Office Action Summary

09/786,110

IURA ET AL.

FIG. 1

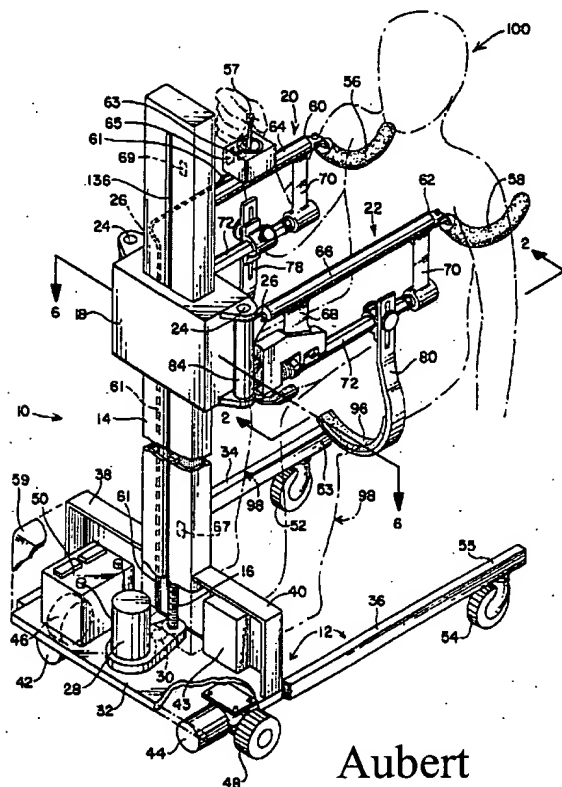
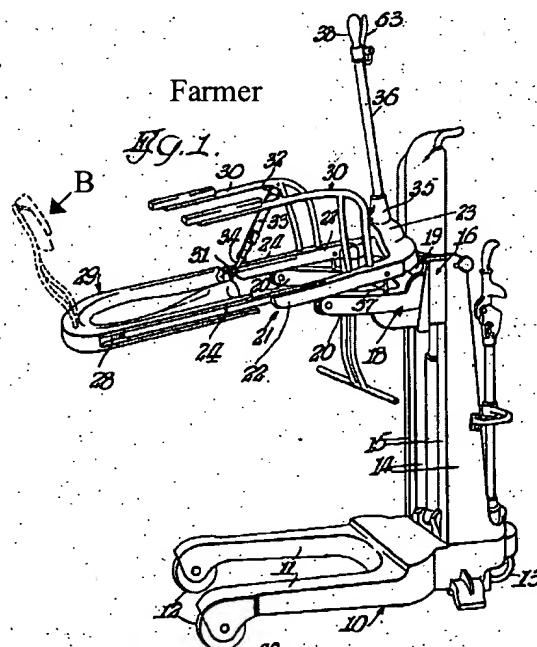
11. As best understood, claims 1 and 2 are rejected under 35 U.S.C. § 103(a) as being unpatentable over Aubert and Farmer. Aubert discloses a supportive device (10) (Figs. 1-9) for helping physically handicapped patients shift from one structure to another comprising a chassis (12) having an open rear end, provided with a pair of front wheels (46, 48) and a pair of rear wheels (52, 54), a pillar (14) erected on the chassis, a pair of arms (72) provided in the pillar, a pair of thigh supports (78, 80) provided in the arms, a handrail (20, 22) whose rear is open, a lifting device (28, 42, 44) for raising and lowering the thigh supports, wherein the arms are eccentrically rotated (Figs. 8a-8c) in accordance with the rotation of shafts (82) axially extending in front of the patient's knees, in the course of the rotation of the arms the thigh supports being

inserted under the patients thighs. Aubert does not expressly disclose a supportive device further including a back upholstery, and wherein the thigh supports are capable of inclining. Farmer teaches a supportive device (Fig. 1) having a chassis (10) and a pair of arms (22); a thigh support (29) capable of inclining (Farmer: col. 5, lines 8-14) and a back upholstery (B). It would have been obvious to one having ordinary skill in the art at the time the invention was made to employ a back upholstery and inclining thigh supports, as taught by Farmer, modifying the supportive device disclosed by Aubert, thus providing back support for the patient during movement of the patient as well as controlled vertical movement of the patient.
